SUBJECT: Forwards changes to Section 6 of emergency preparedness plan (EPP), Rev 11 re EALS & Figure 4.2 of EPP, Rev 12 re footnote symbol for CR Supervisor & Shift Technical Advisor positions on subj figure entitled, "...Organization."

October 30, 1992
G02-92-245

Subject: WNP-2, OPERATING LICENSE NPF-21
CHANGES TO THE WNP-2 EMERGENCY PREPAREDNESS PLAN

FIGURE 4-2. NORMAL WNP-2 OPERATING ORGANIZATION

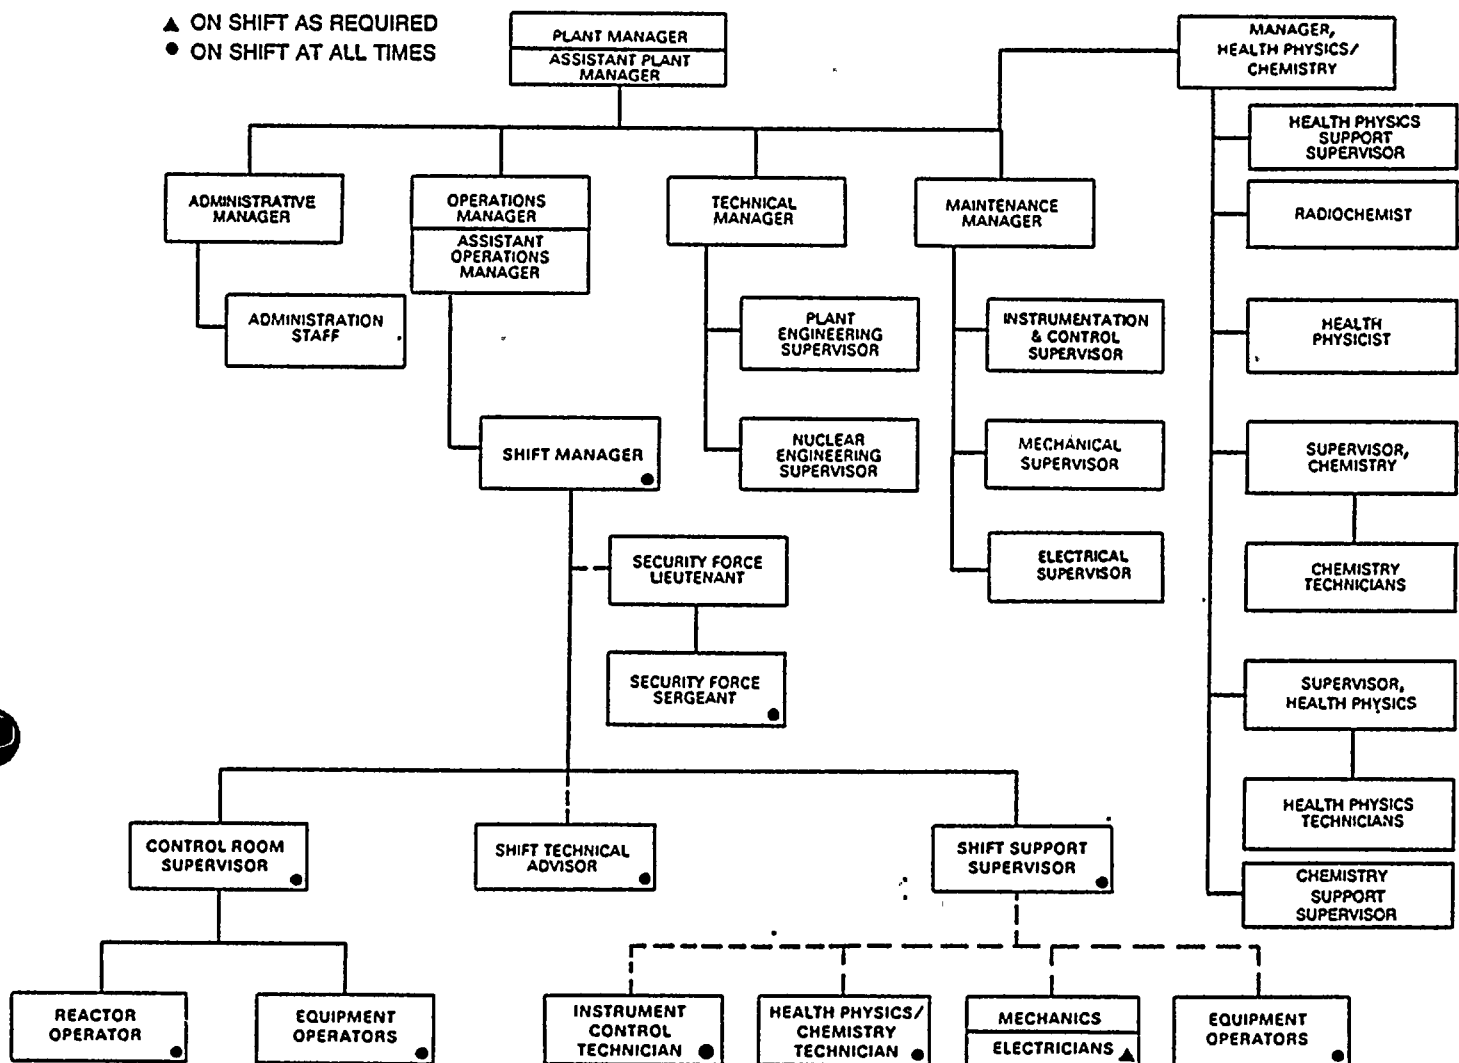
Figure 4.2 of our EPP is an organizational chart that represents the normal WNP-2 operating organization. By footnote symbol on that chart we had indicated that our Control Room Supervisor (CRS) and Shift Technical Advisor (STA) positions were on shift at all times.

This is not a correct representation of how we are operating. In accordance with our Technical Specification Table 6.2.2-1, the CRS and STA are required to be on shift for operating Modes 1, 2 and 3. They are not required to be on shift in Modes 4 and 5.

Guidance on this position for the CRS and STA is also contained in NRC Generic Letter 80-72, dated July 31, 1980, entitled, "Interim Criteria For Shift Staffing", and NUREG-0737, Enclosure 3, Sections I.A.1.1 and I.A.1.3.

The Supply System proposes to change the footnote symbol for the CRS and STA positions on the Figure 4.2 chart to reflect "On Shift As Required", rather than "On Shift At All Times".
